ADDENDUM NO. 02

CLOVIS COMMUNITY COLLEGE SPORTS COMPLEX
Fresno, CA 93730
2425-22

DARDEN PROJECT NO. 2175
DSA File Nos. 10-C3
DSA APPL. NO. 02-122242

The following additions, deletions, and revisions to the SHEETS and Project Manual are hereby made and do become a part of these Contract Documents.

X/T302

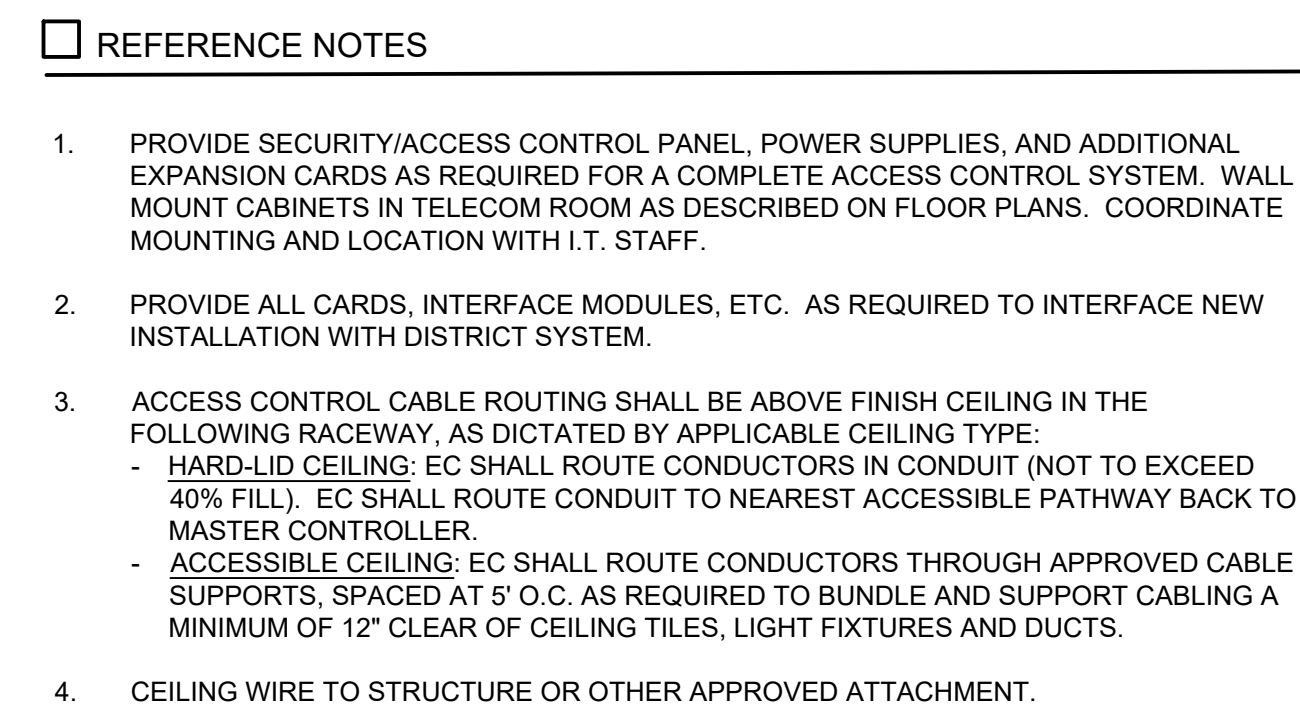
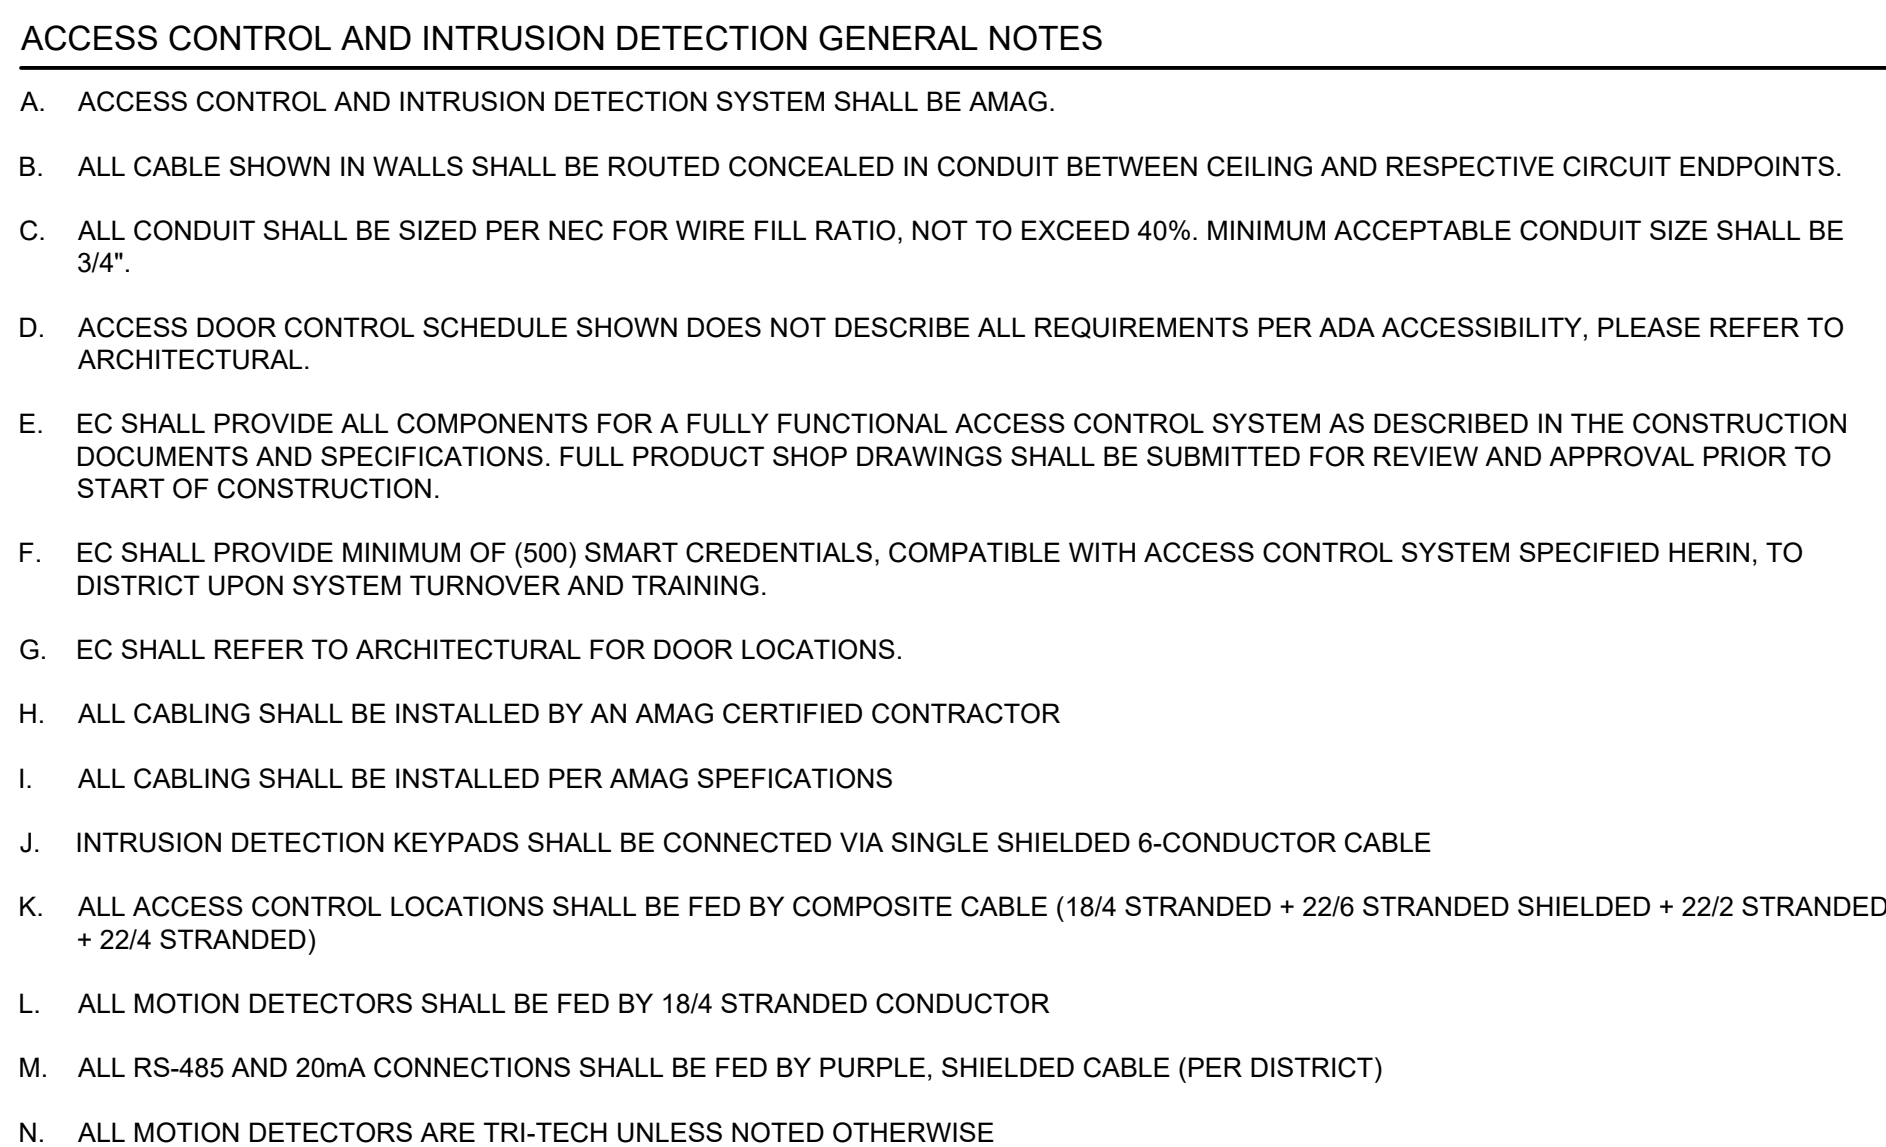
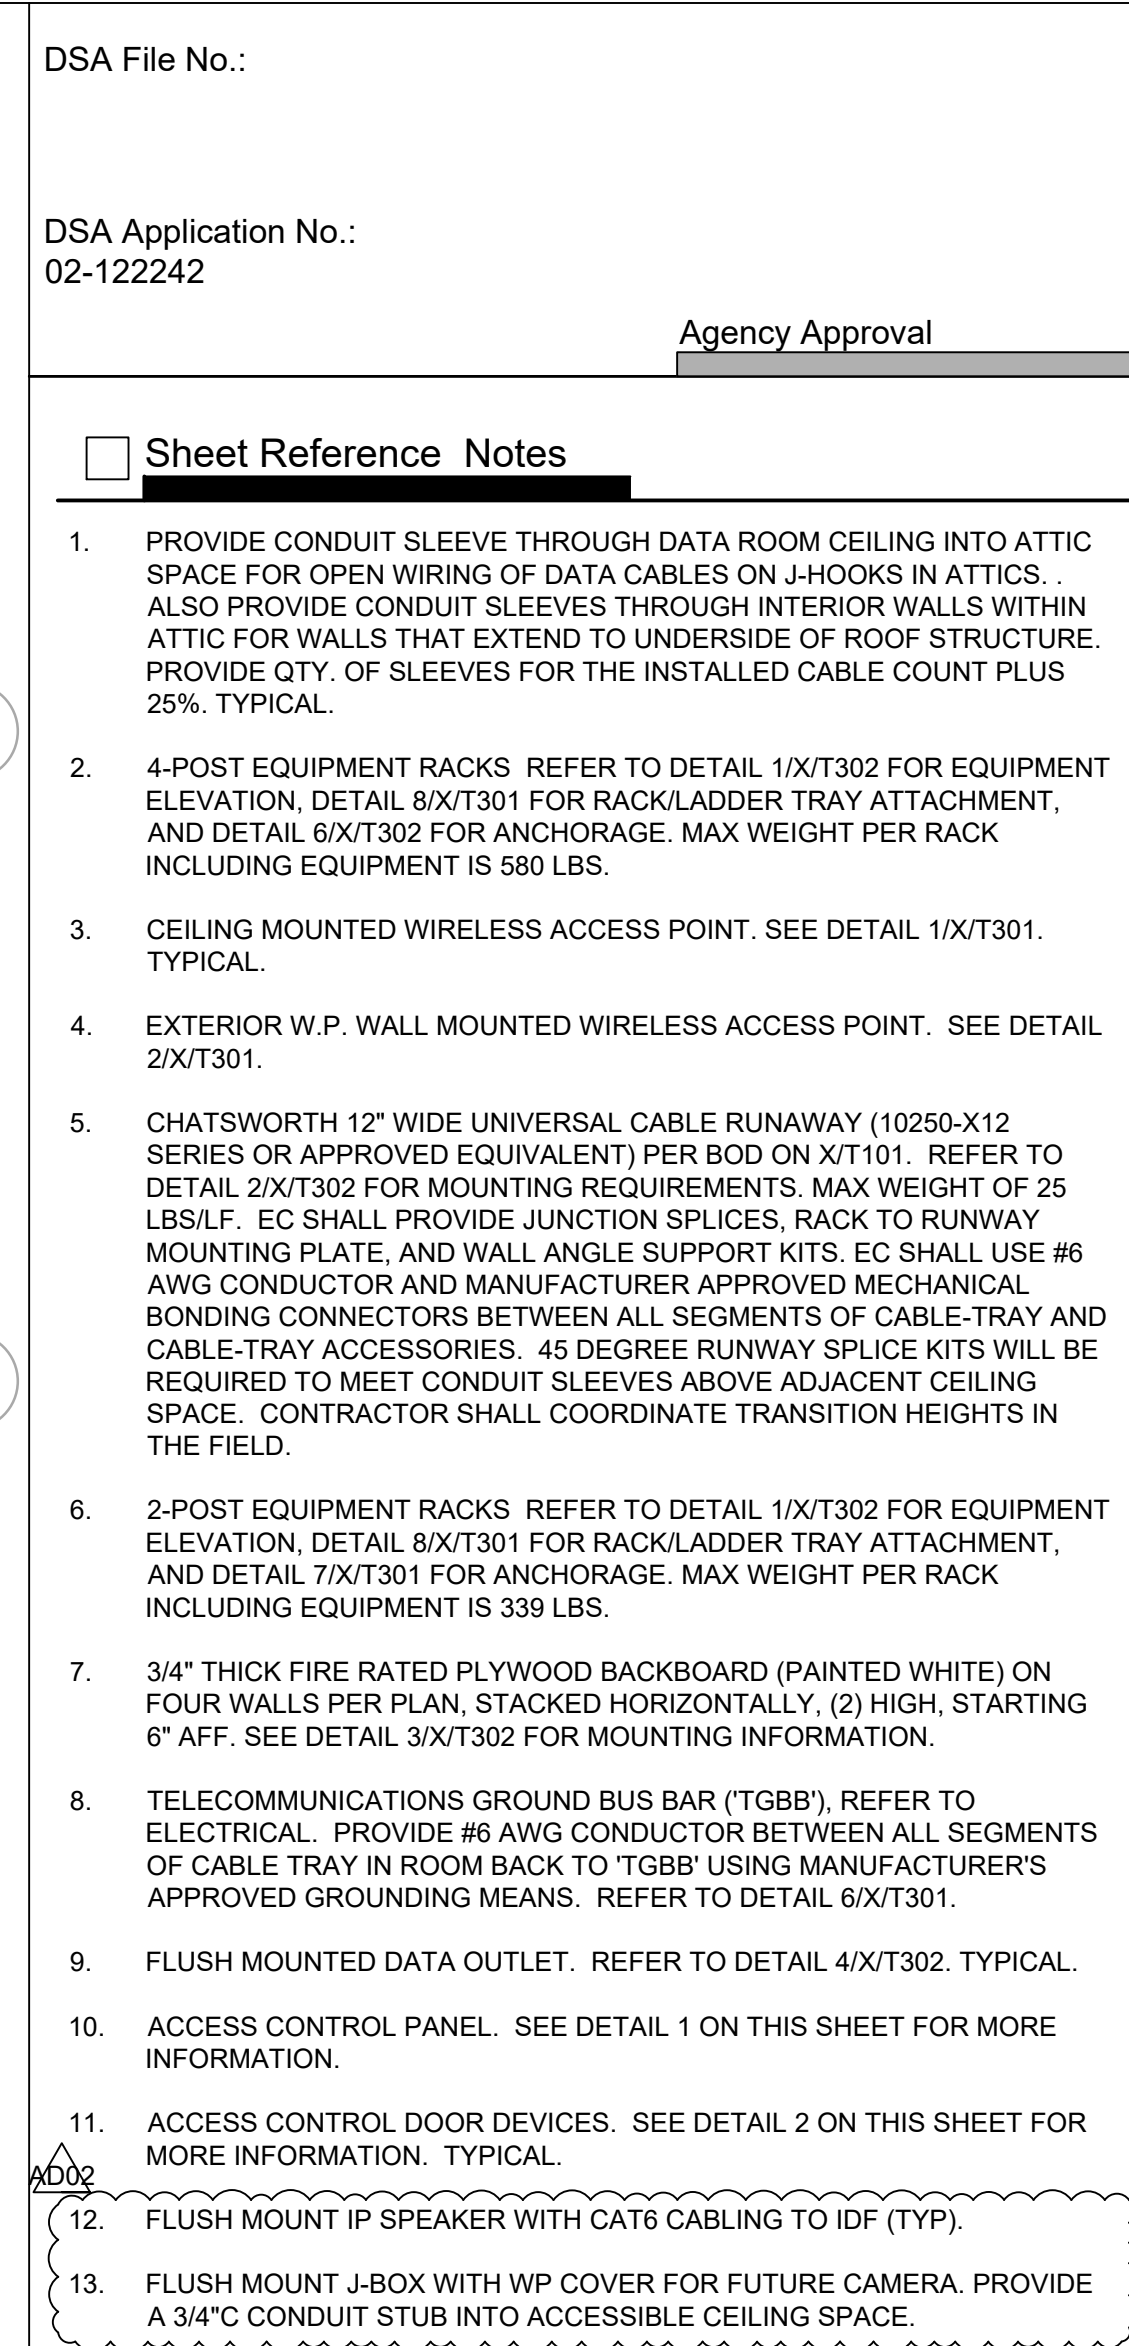
AD02-T03 Refer to Sheet X/T302, and attached drawing AD02-TX03:

1. Refer to Detail 1. Revise the note regarding CAT6A Patch Cord length. Revise the dimensional requirement for the Vertical Cable Managers.
2. Refer to Detail 2. Revise the Detail to remove the Unistrut wall attachment and connect the cable runway support bracket directly through the plywood backboard and into wood blocking.

3. Refer to Detail 4. Revise the Detail to reflect the current SCCC standard for voice/data outlet and cable labeling.
4. Add Detail 7 for underground fiber optic cable to be installed in an fabric style innerduct.
5. Add Detail 8 for ground mounted Remote IDF to be located below bleachers / press box.
